PROJECT OWNER : CK CAPITAL, LLC
PROJECT DESCRIPTION : CLEVELAND BROTHERS-MILESBURG
PROJECT ADDRESS : 4025N. EAGLE VALLEY ROAD, HOWARD, PA 16841
CONTRACTOR : KINSLEY CONSTRUCTION, INC.

DWG DESCRIPTION : GUARDRAIL & LADDER PLAN

SK#19
12-09-2025

2 E703 LUBE ROOM DUST CAP (LADDER AND GUARDRAIL PLAN)

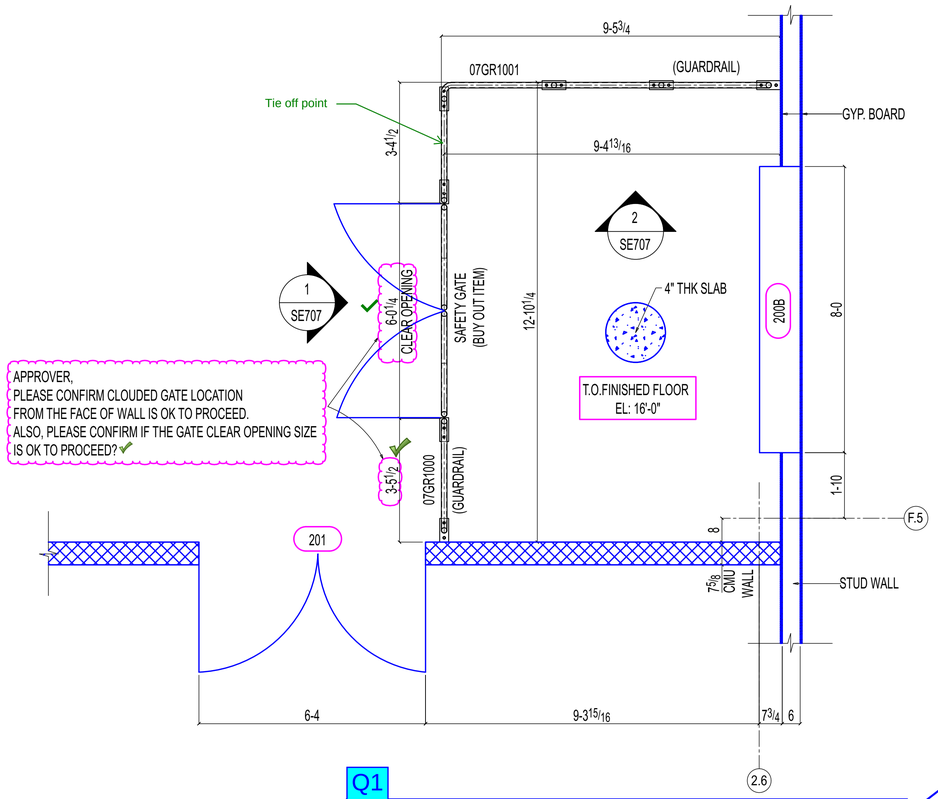
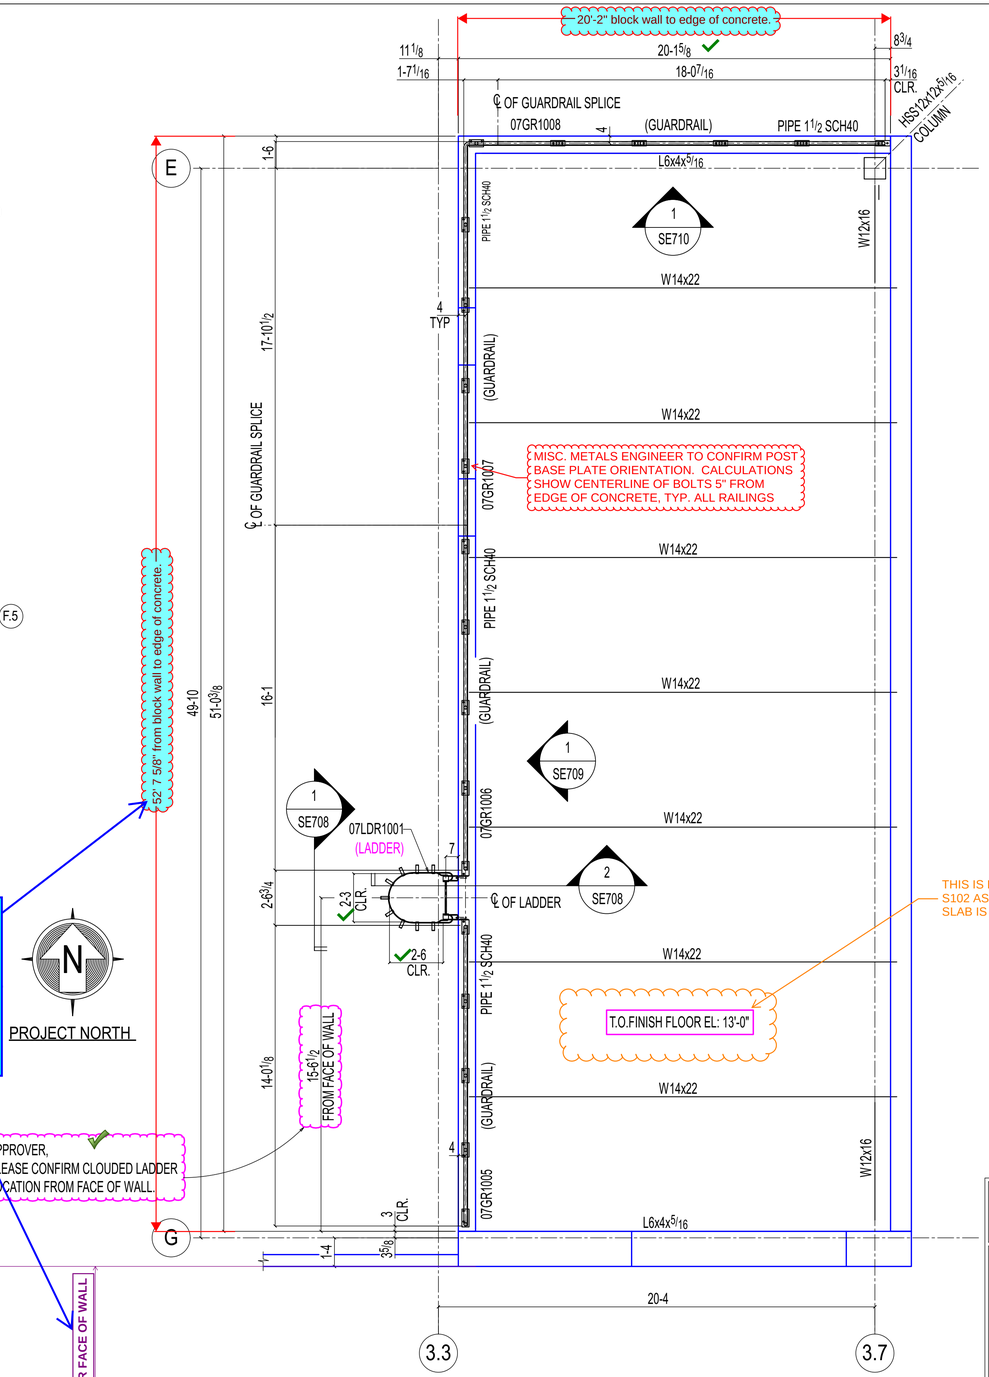
APPROVER,
WE HAVE FOLLOWED 1 1/2" SCH 40 PIPE FOR
THE FLOOR GUARDRAILS. PLEASE CONFIRM IF IT IS ACCEPTABLE.

Q1
Please advise on clouded field measurement if the survey dimension measured between outer face of the wall or the inner face of wall? since we have 1-0 + deviation comparing to arch dimensions.

APPROVER,
PLEASE CONFIRM CLOUDED LADDER
LOCATION FROM FACE OF WALL.

APPROVER,
WE HAVE FOLLOWED 1 1/2" SCH 40 PIPE FOR
THE FLOOR GUARDRAILS. PLEASE CONFIRM IF IT IS ACCEPTABLE.

THIS IS INCORECT. REFER TO SHEET
S102 AS THE TOP OF CONCRETE
SLAB IS SHOWN AS +15'-0" AFF

1 E704 HOSE ASSEMBLY DUSTCAAP (LADDER & GUARDRAIL PLAN)

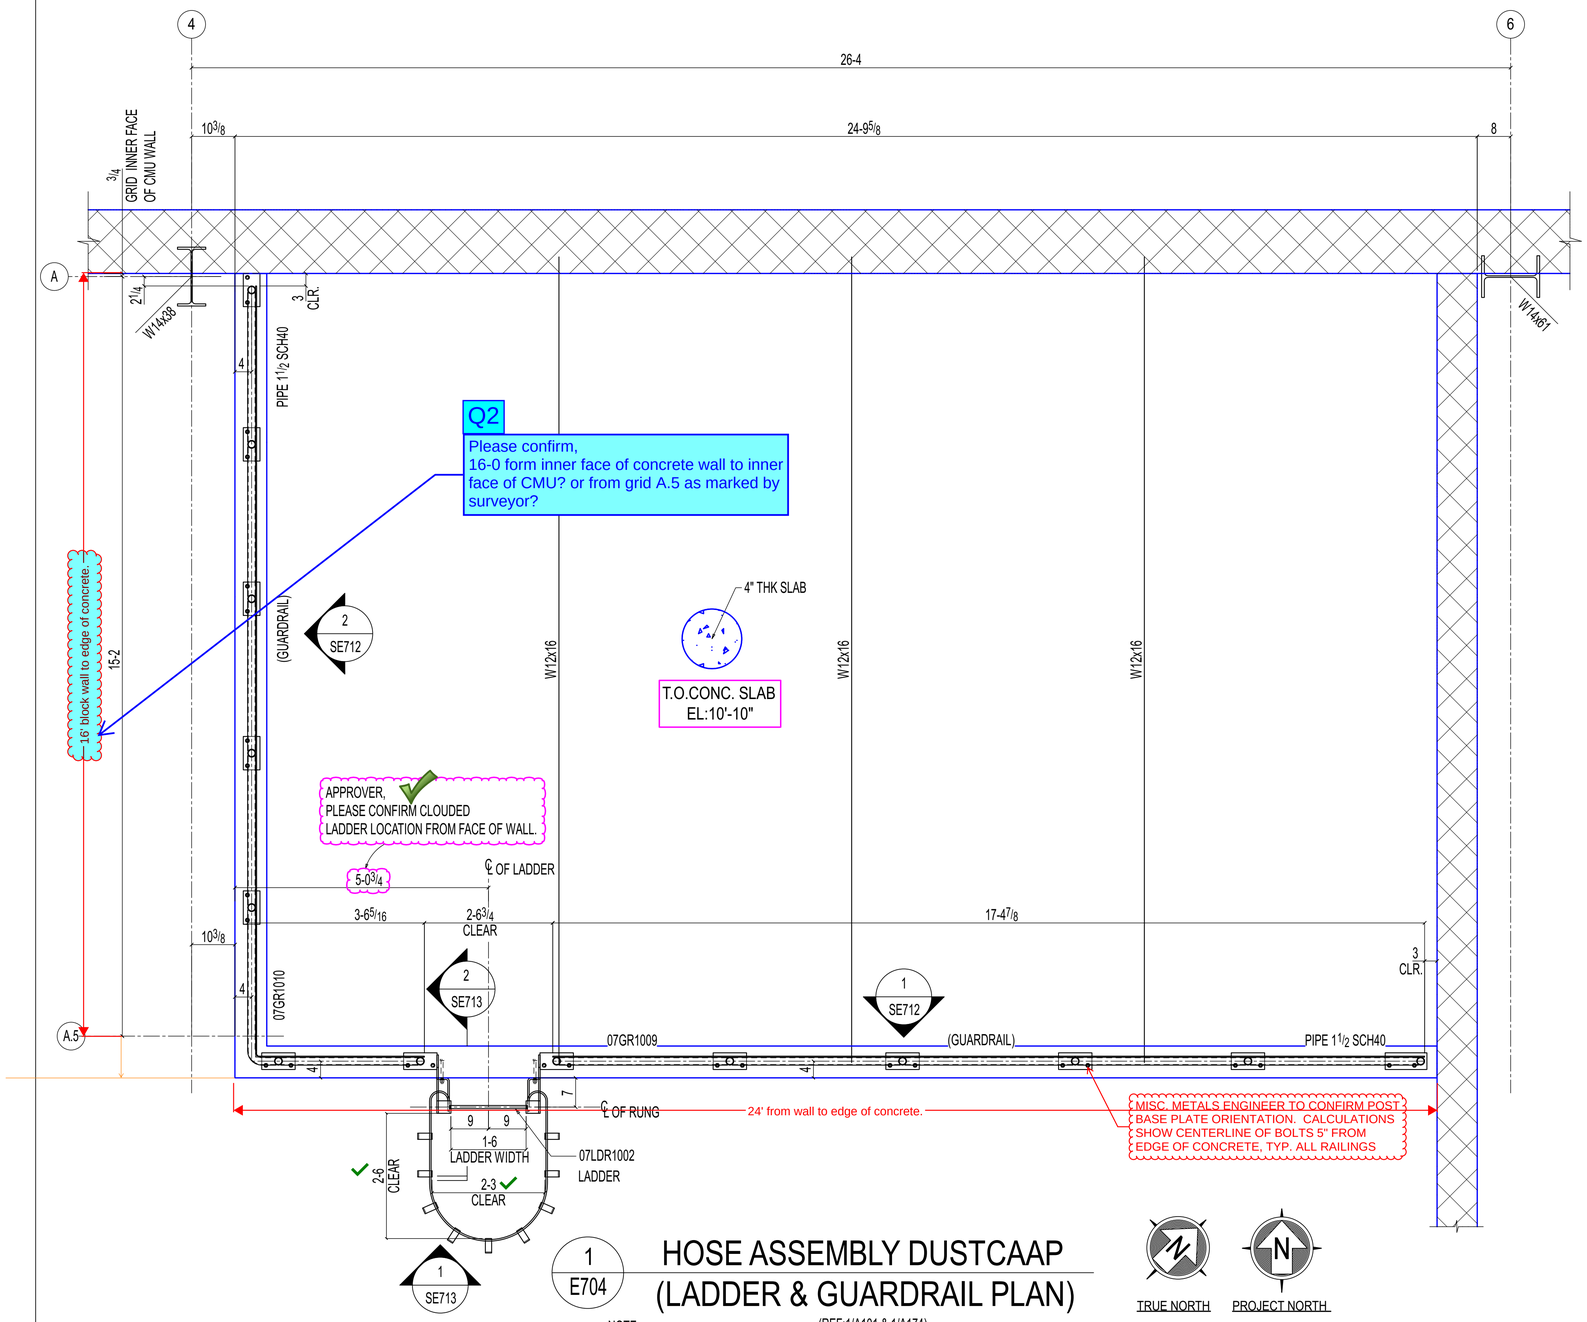
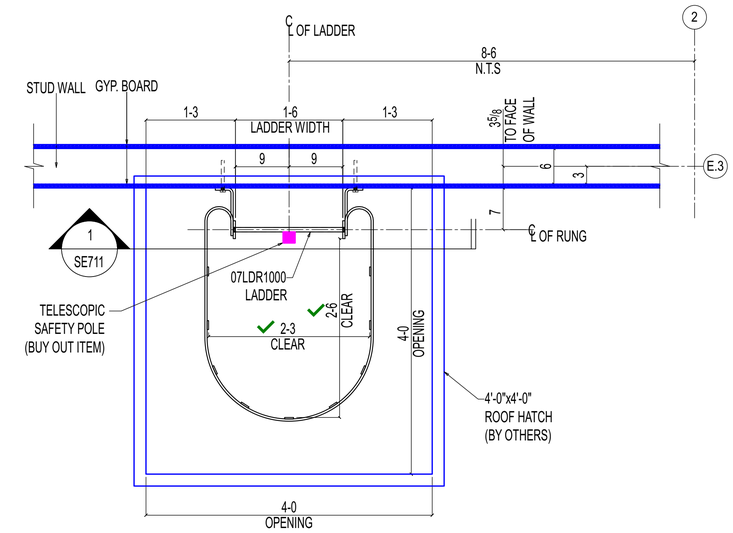
APPROVER,
WE HAVE FOLLOWED 1 1/2" SCH 40 PIPE FOR THE FLOOR GUARDRAILS.PLEASE CONFIRM IF IT IS IT OK TO PROCEED?

REFUSE CONTAINER ENCLOSURE
GATE FRAMING PLAN

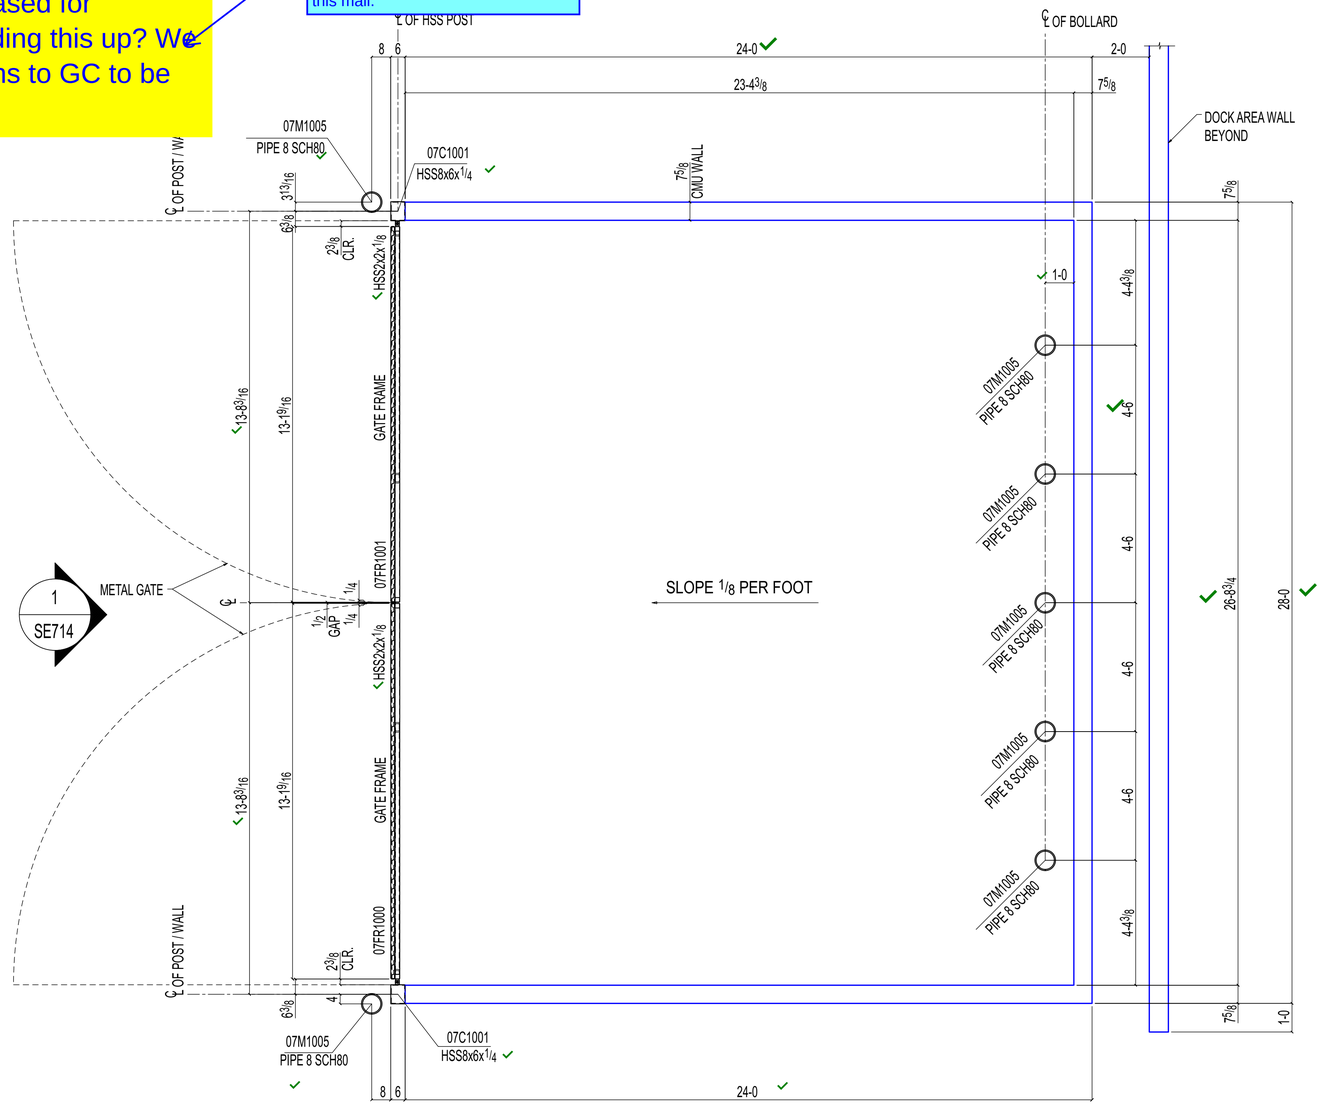
Gate has not been released for fabrication. What is holding this up? We need to get gate columns to GC to be embedded.

We need responde for SK#17-Q10 to proceed further.
Please see the attached SK#17 in this mail.

DWG DESCRIPTION : STAIR ELEVATION VIEW

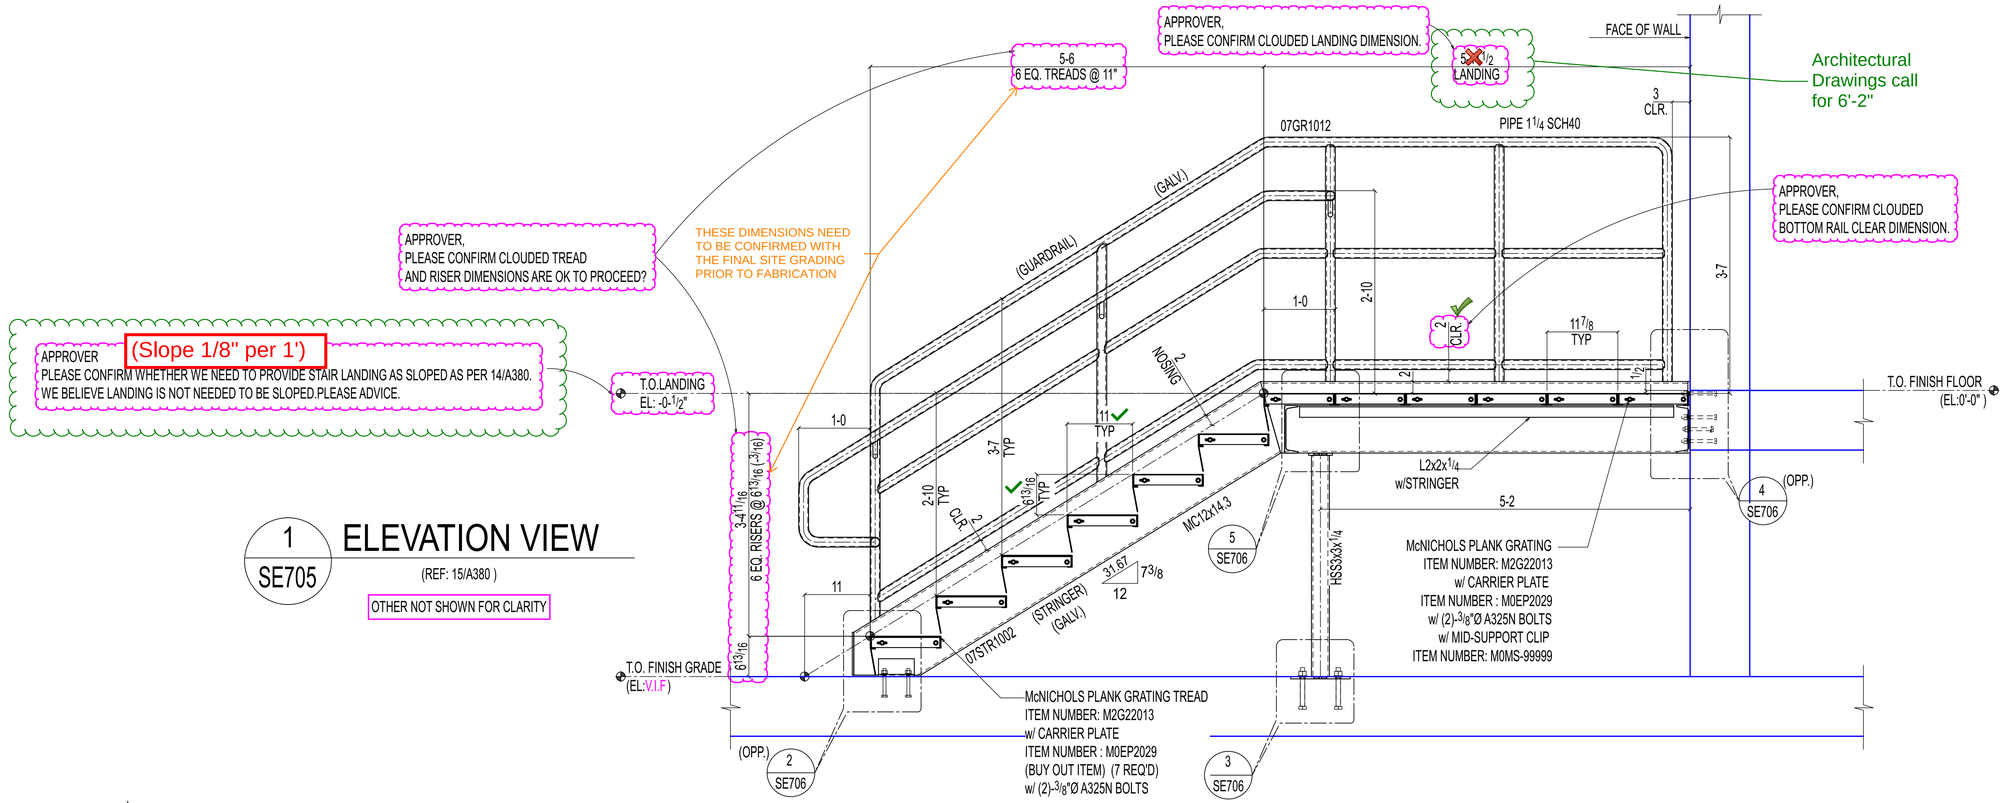
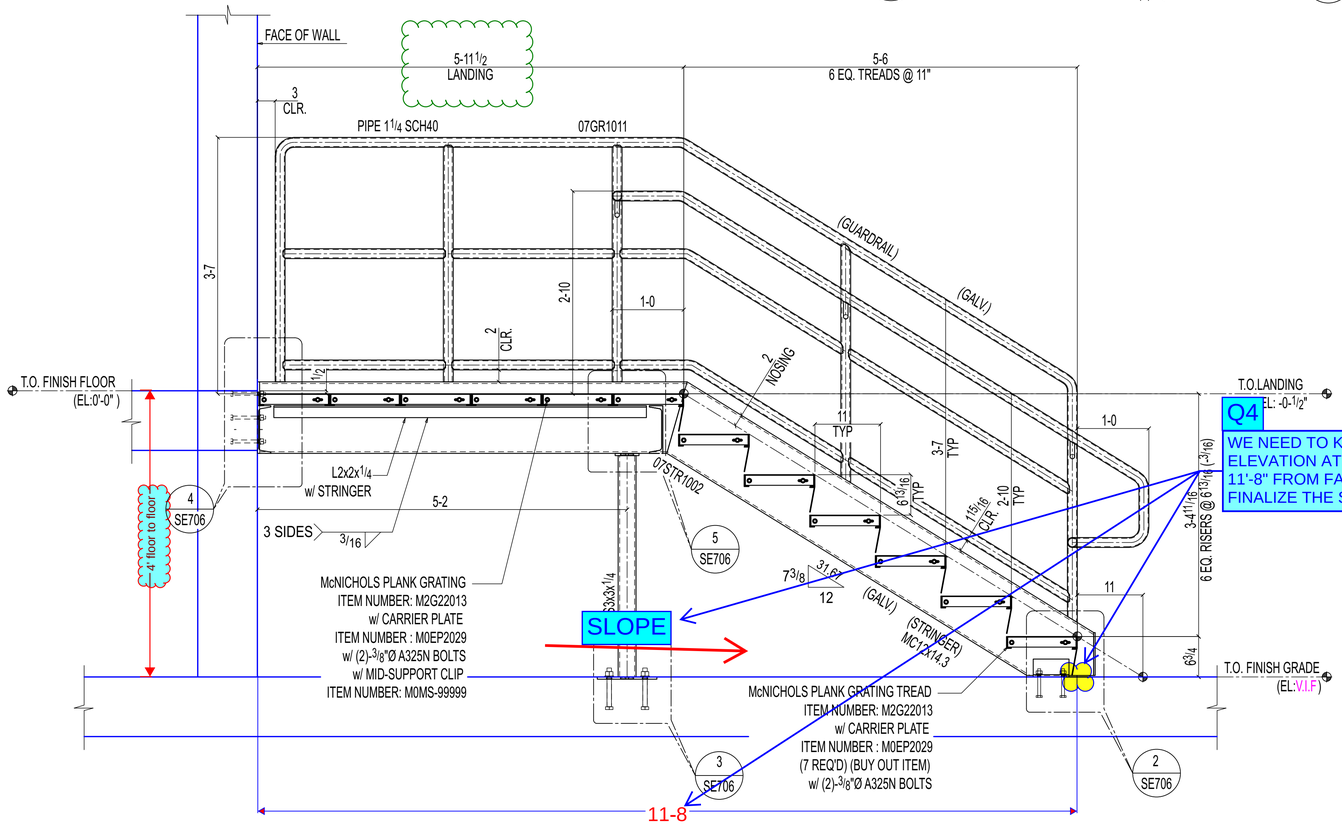
APPROVER,
PLEASE CONFIRM CLOUDED STAR LOCATION (CHANNEL OUTER END)
FROM DOOR OPENING IS OK TO PROCEED?
